4548 PERKINS RD

CERTIFICATE OF COMPLETION/OPERATION PERMIT

Michael Ward Lot - 4600 Perkins Road

Shallow Placed Gravity Fed Modified System .1956(3)(a)(ii)
(Prefabricated Permeable Block Panel System - T & J Panels)

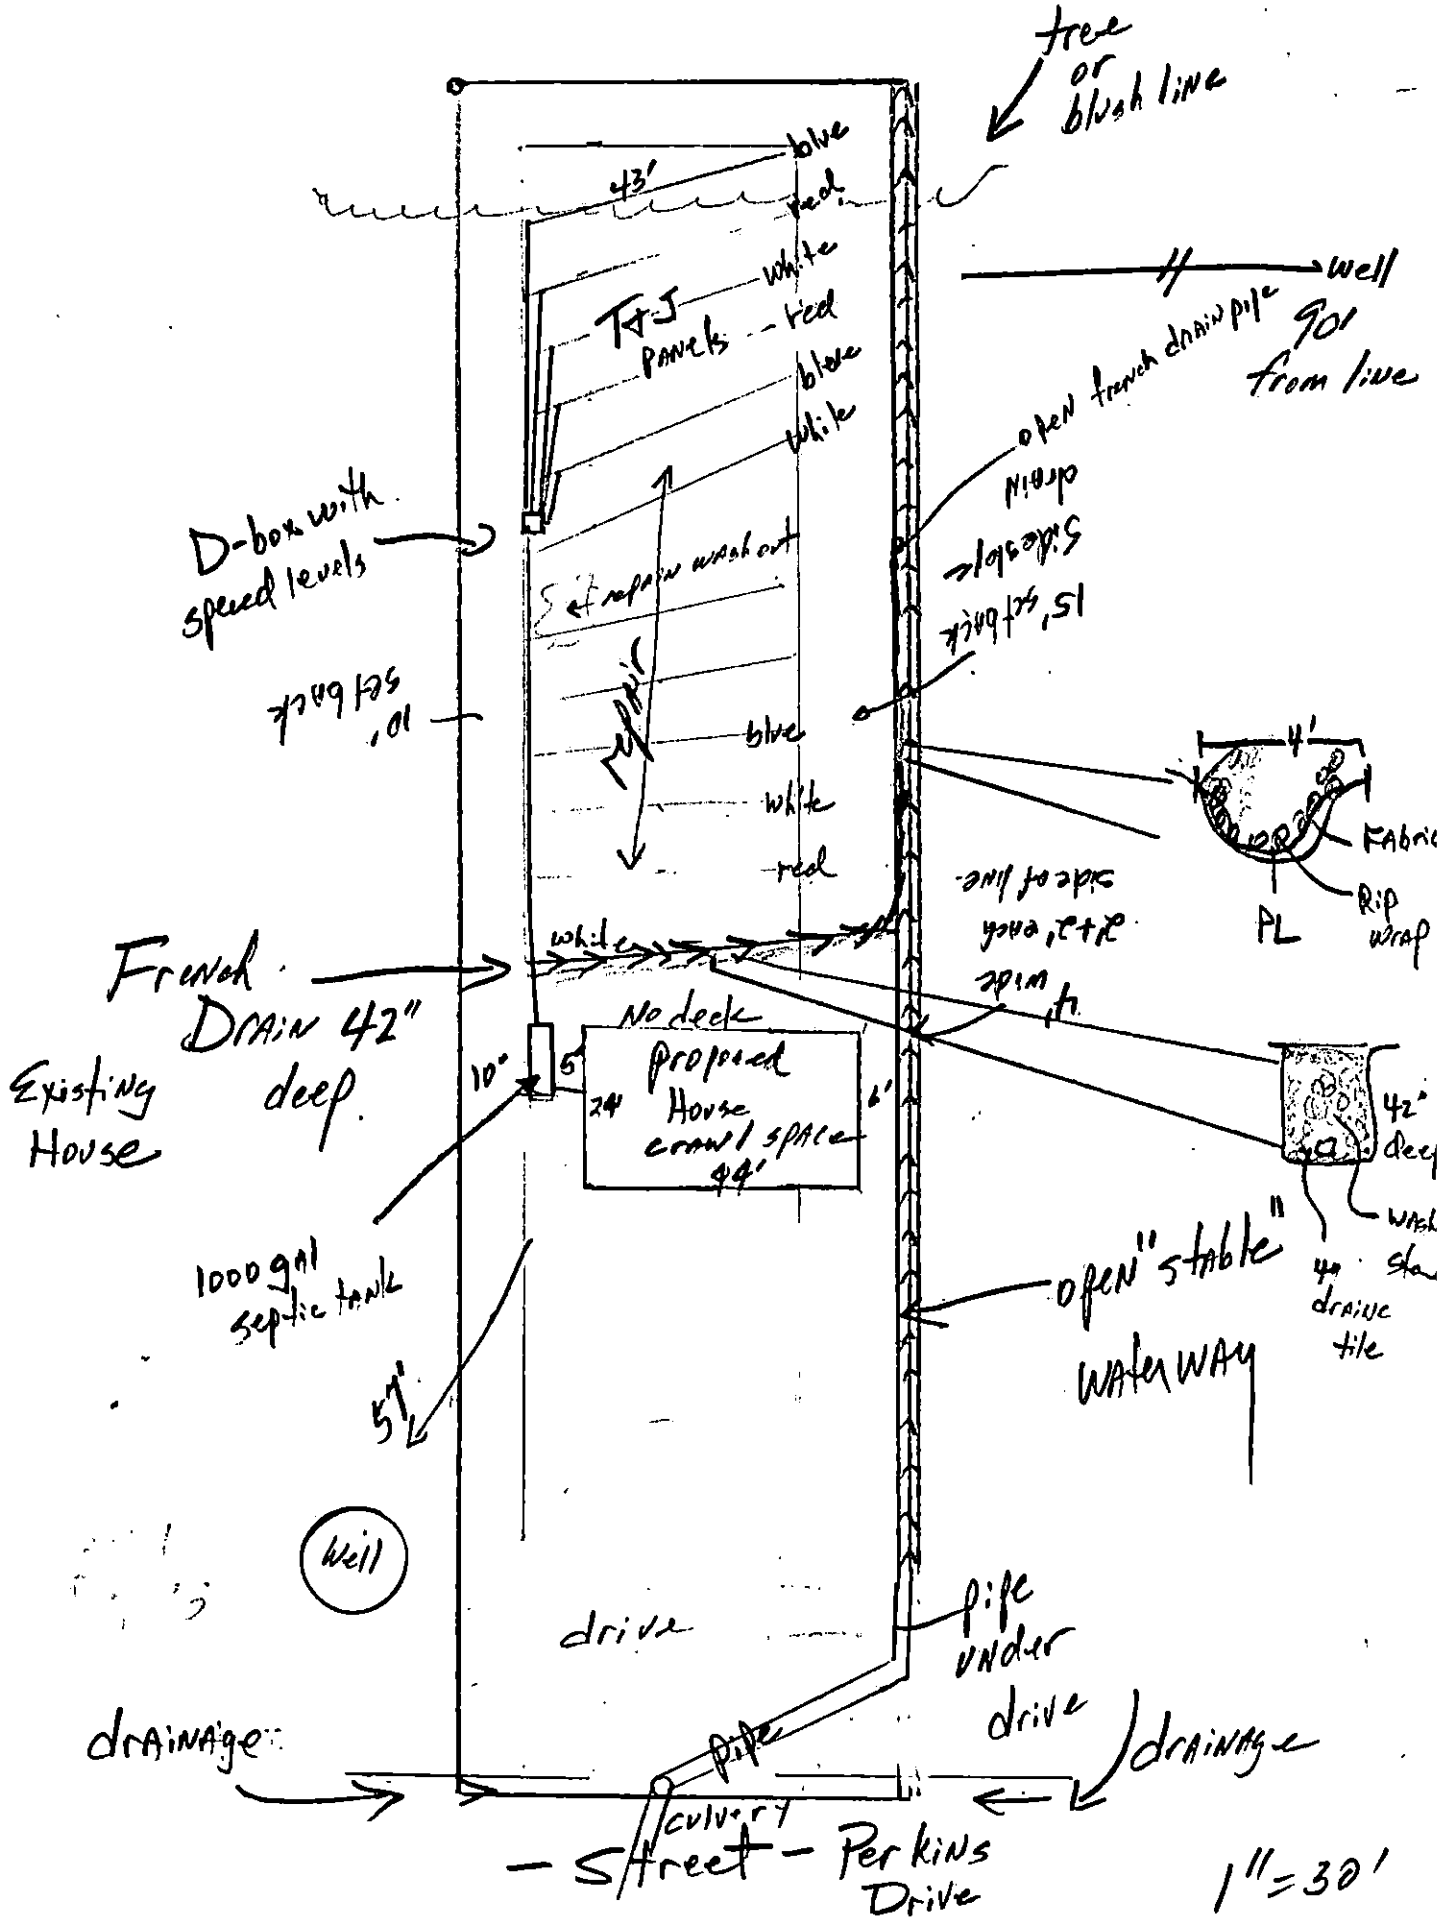
1. Lines have been flagged as noted on drawing. French drain should be installed as shown. Swail should be installed and stabilized.
2. Clear the lowest drainfield line area of all organic material with minimum soil disturbance (do not grade).

Only panels were considered permittable with the above site criteria. A caution to the installer includes no cutting or leveling of the soil, except by fill added to the surface. A 42" deep French drain, and a surface swail along the side of the lot are required as shown on the plan. This interceptor drain must be checked by inspector before trench is closed because of importance to the system.

PROPOSED PLOT PLAN

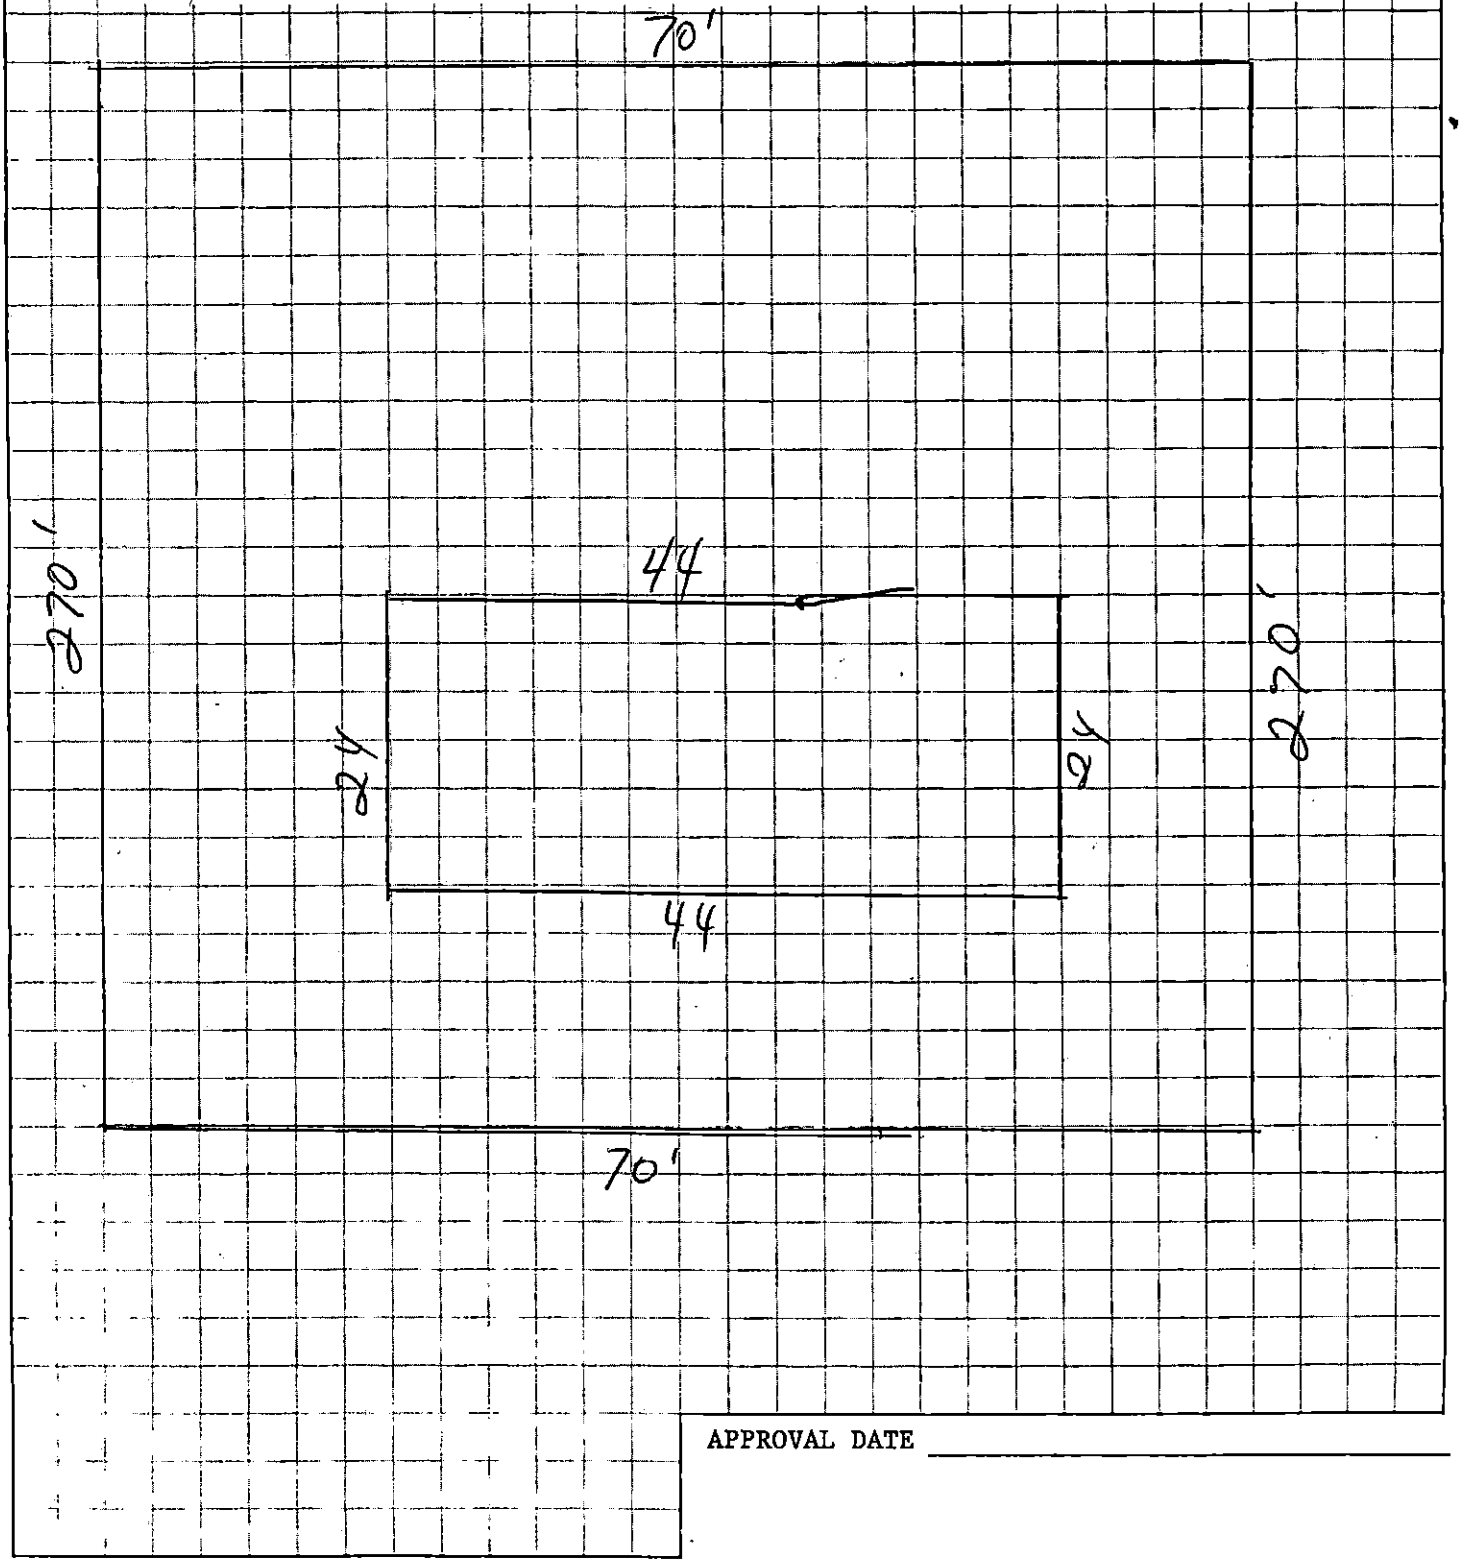
There is not sufficient available space for the septic tank system as per the submitted plan. Rule .1945 (a) states that; sites shall have sufficient available space to permit the installation and proper functioning of ground absorption sewage treatment and disposal systems, based upon the square footage of nitrification field required for the long term acceptance rate determined in accordance with the Rules. (b) Sites shall have sufficient available space for a repair area separate from the area determined in paragraph (a) of this Rule.

Possible ways to develop this site include design of a system following .1956 Modifications to Septic Tank Systems (1) (ii) and decreasing the design daily sewage flow. Plans for a system such as this would need to be submitted to our office with the appropriate fee.

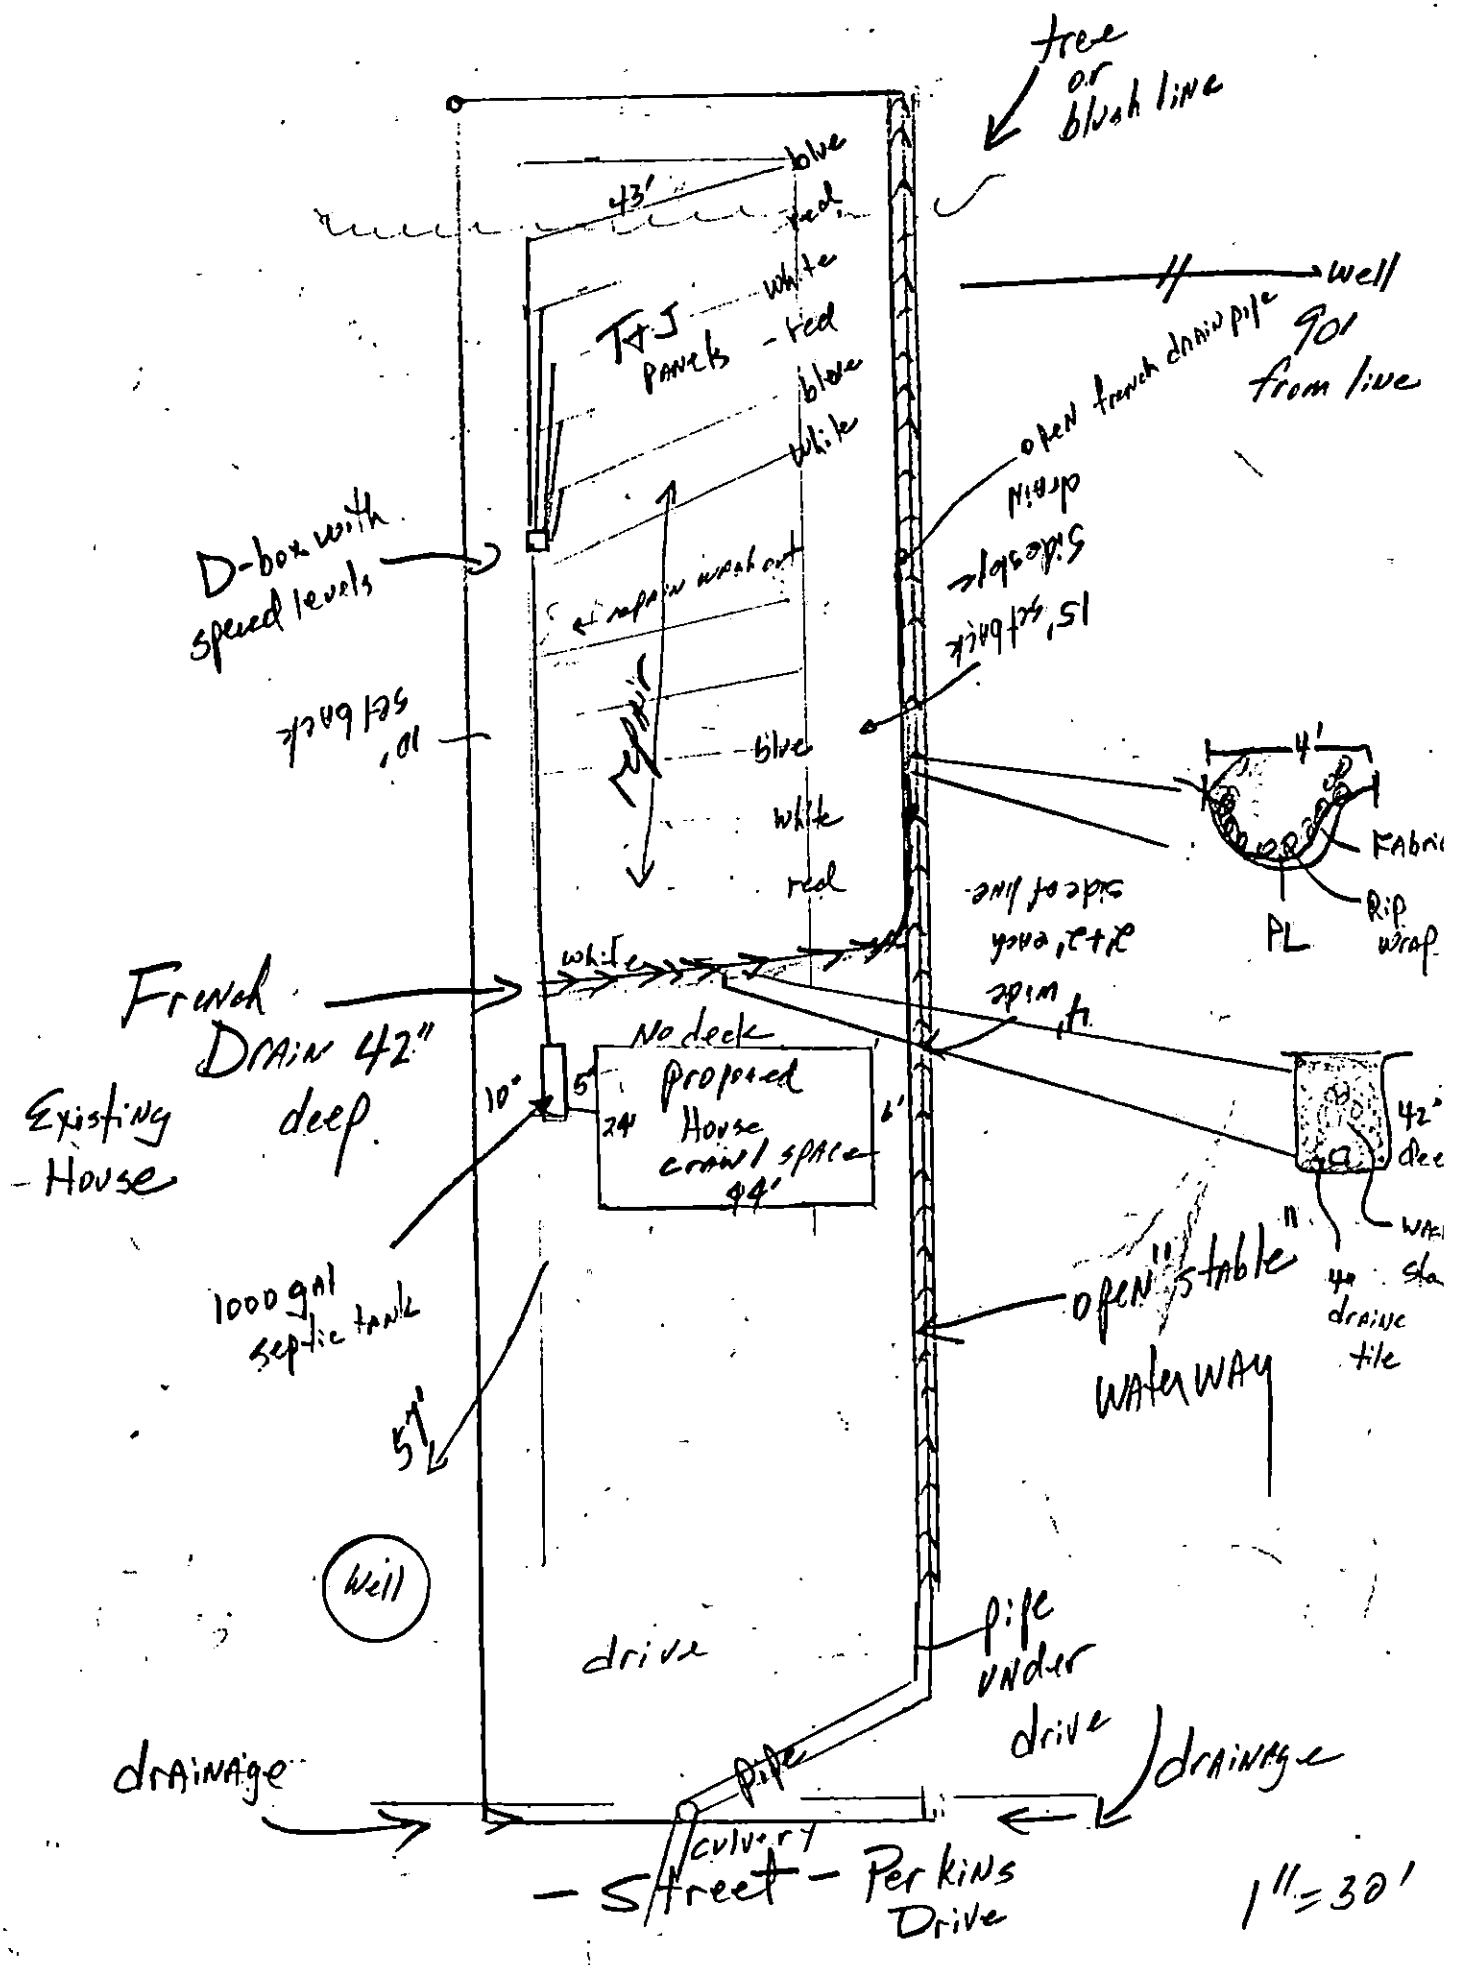
Your plans for the modified system for the above property as submitted are approved with the following comments:

-The well should be located 100 feet, but in no case less than 50 feet from the sewage system and repair area.

An Improvement Permit can be issued after the endorsed "Septic Tank Agreement forms are executed and recorded at the Mecklenburg County Register of Deeds office."
